Comment on Representation Relating to Draft Plan

**Comment on the Representations to
Draft Wan Chai Outline Zoning Plan No. S/H5/28**

Lee Theatre Realty Limited
Representation on the Draft Wan Chai Outline Zoning Plan No. S/H5/28
Relating to Lee Theatre Plaza, 99 Percival Street, Causeway Bay

**Leighton Property Company Limited
Representation on the Draft Wan Chai Outline Zoning Plan No. S/H5/28
Relating to Leighton Centre, 77 Leighton Road, Causeway Bay**

Figure 3 : 135mPD OZP and SBDG Compliant Scheme.

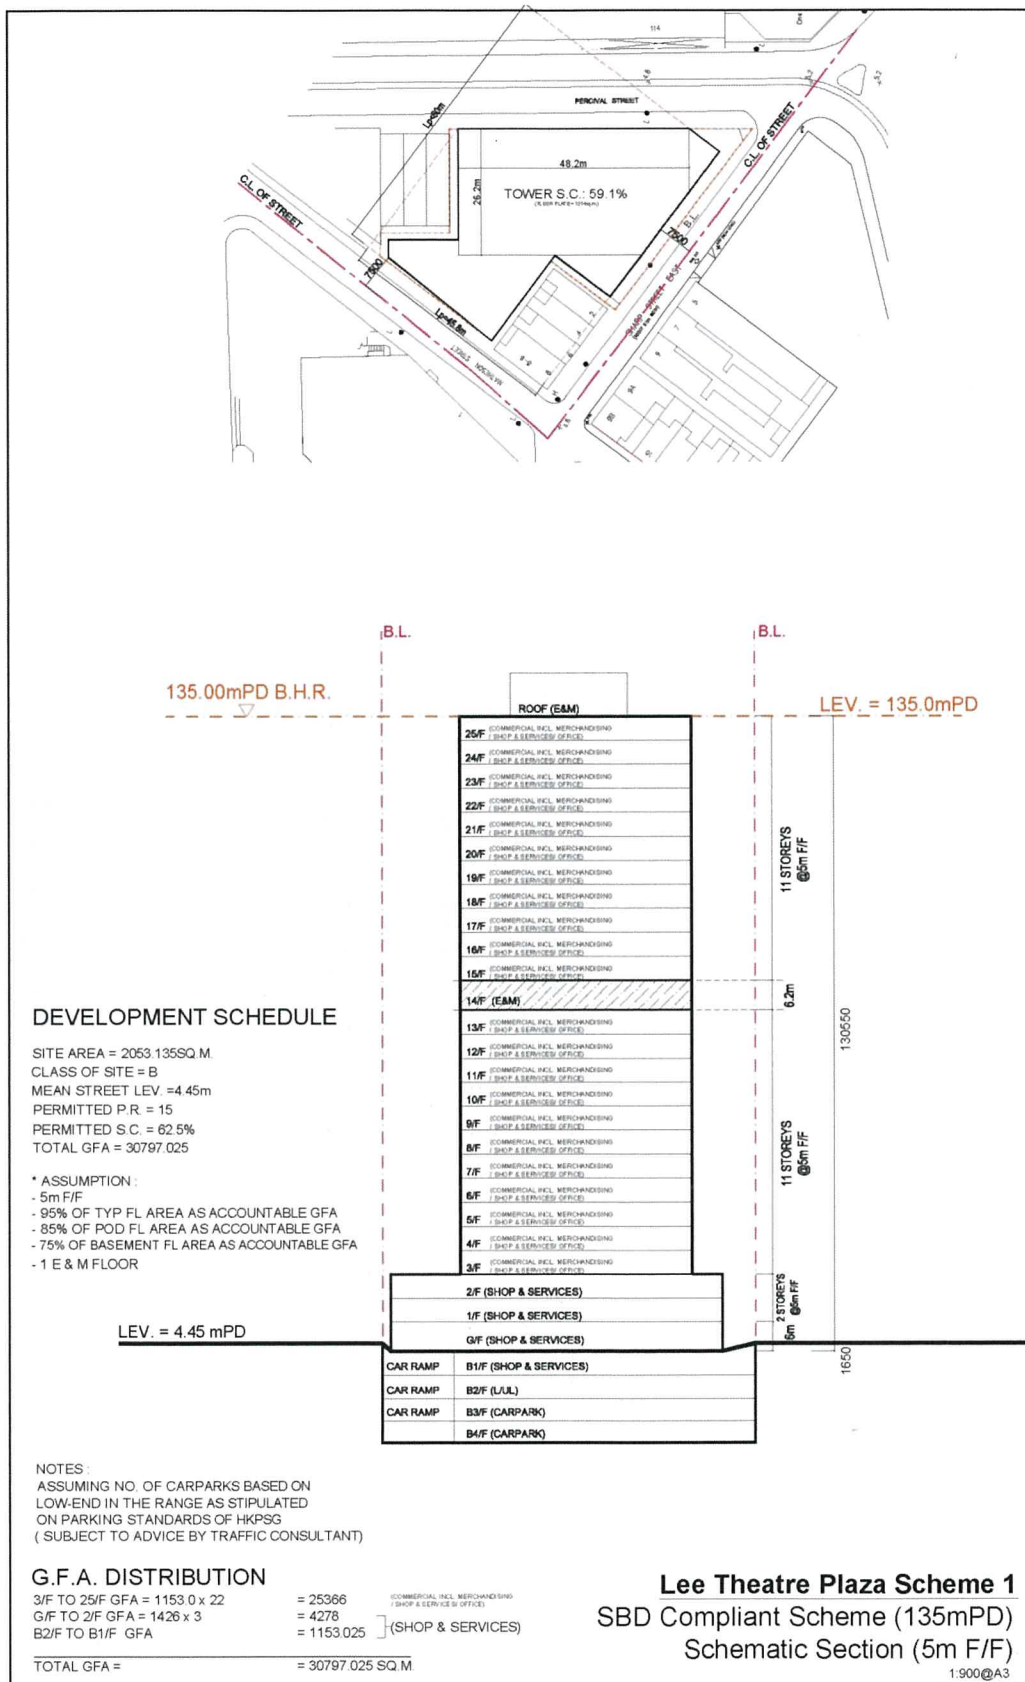
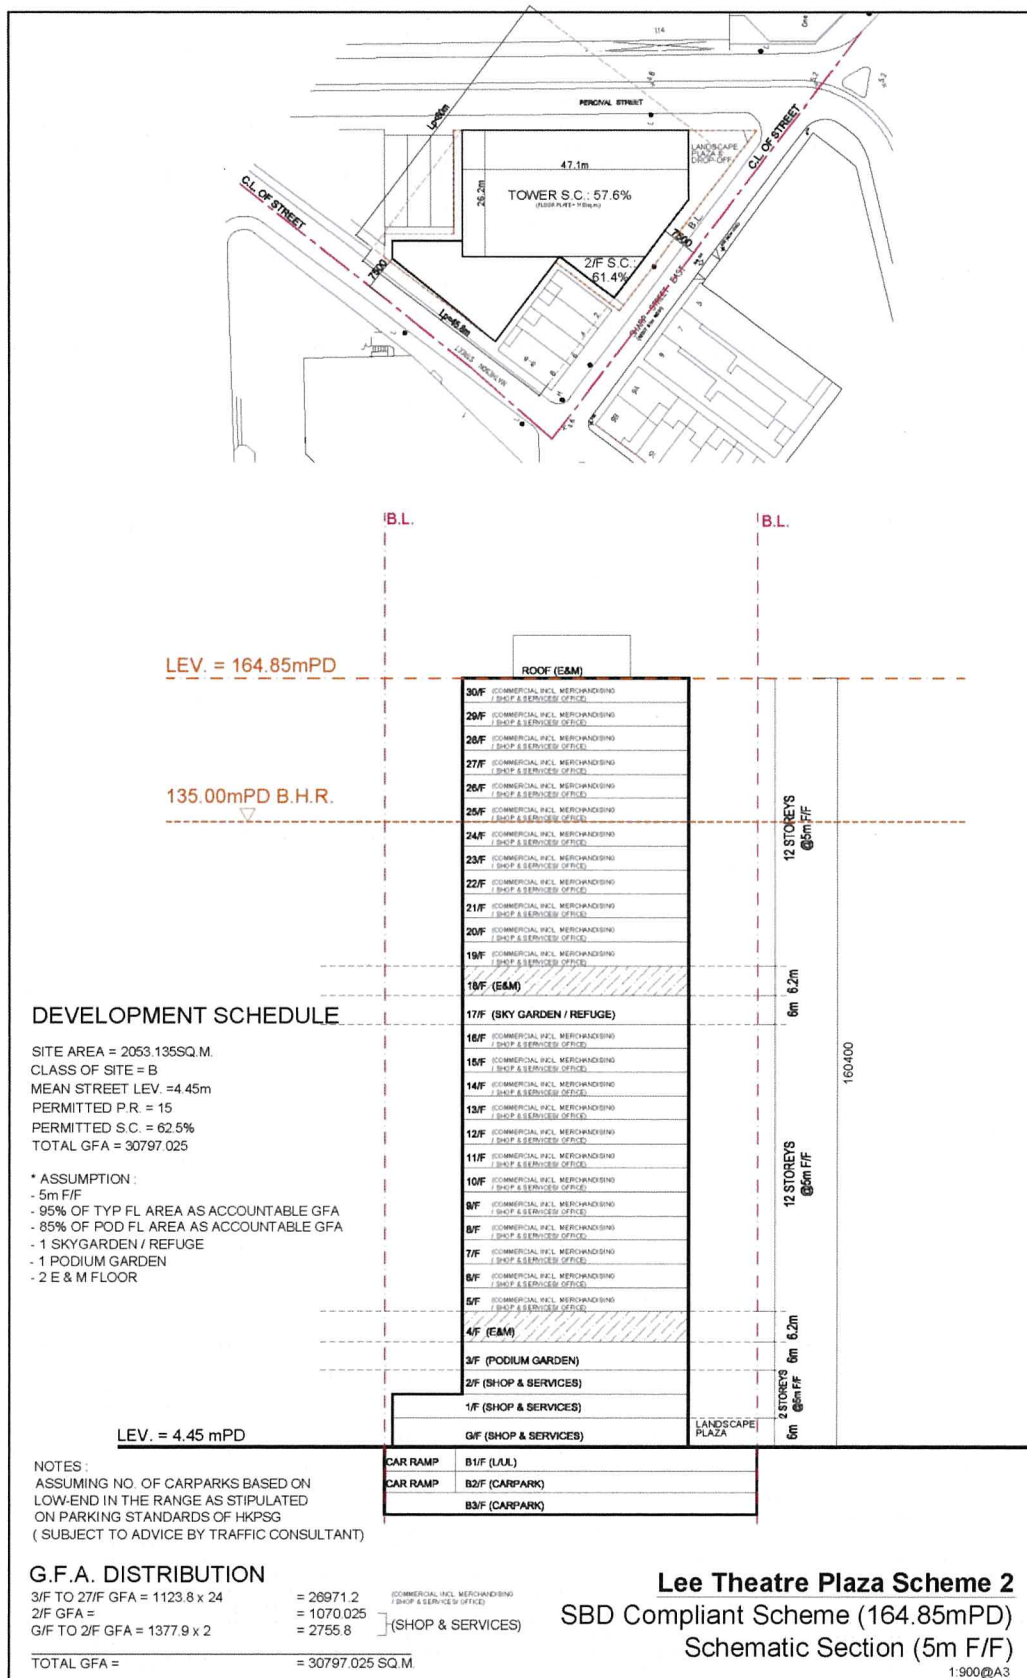
- 9.1 The Representor's AP has been requested to prepare two schemes to illustrate the different options for the site. The first scheme (**Figure 3**) is the 135mPD scheme showing the impact of the normal application of the SBDG on the development of the Lee Theatre Plaza site under the 135mPD BHR. The second is an indicative scheme of some of the features that could be incorporated if the BHR was raised to 165mPD (**Figure 4**).

- 9.2 This scheme is designed to comply with the proposed 135mPD BHR (see **Figure 3**). To comply with the SBDG it is necessary to have a small podium setback at the ground floor level on Sharp Street East, in addition to a very small setback on part of the building frontage onto Matheson Street. The length of the tower is limited due to the smaller size and unusual shape of the site the building length makes it difficult to have an efficient floorplate. The Ginza Style Commercial building (see **Figure 7**) needs a 5m floor-to-floor height to cope with modern requirements, which has been generally accepted by Buildings Department, and therefore this is the assumed floor-to-floor height.

- 9.3 The relatively low BHR of 135mPD necessitates the provision of one basement floor below ground level to accommodate the balance of the GFA. This is contrary to the assumption made by Planning Department not to have any such floor for these uses in the basement. With the parking and loading/unloading requirements, this would effectively mean provision of 4 basement levels, which is an unnecessarily large excavation, environmentally unsustainable, and expensive.
- 9.4 There are no green features or amenities able to be accommodated within the building design such as sky gardens in the 135mPD Scheme.

Figure 3: Photomontage showing the view from the Stubbs Road Lookout Point.

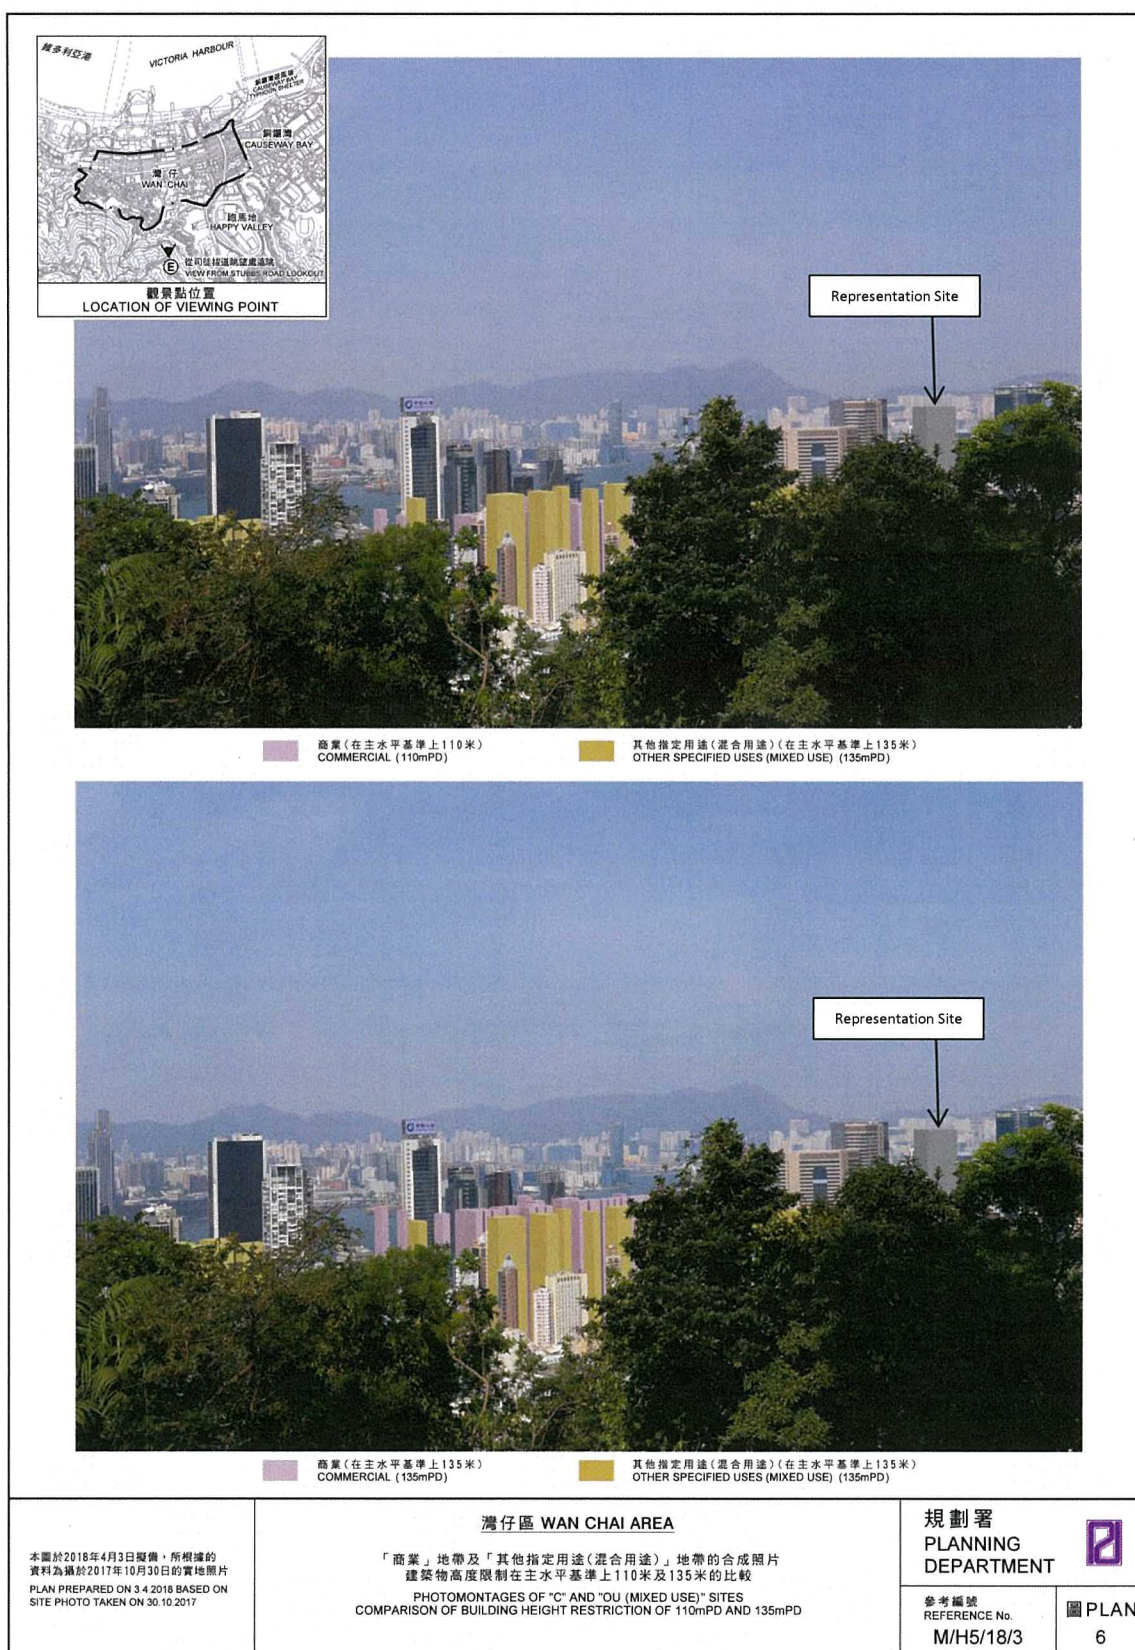
However, there is no real justification given for the 135mPD BHR. If we look at the photomontages prepared by Planning Department which were included in the TPB Paper as Plans 9A-9E it becomes apparent that the Leighton Centre at 200mPD is either not visible or so insignificant it is visually very difficult to distinguish where it is. Plan 9E, is the specifically mentioned photomontage in relation to this site of the view to the harbor from Stubbs Road Lookout Point (**Figures 2 and 3**). It seems difficult when looking at this photomontage to describe the approved GBPs as excessively tall or affecting the view to the point where the “societal benefits” outweigh the burden placed on the landowner. In fact, the building appears to be visually in context with those surround it and rather visually insignificant from this viewpoint.
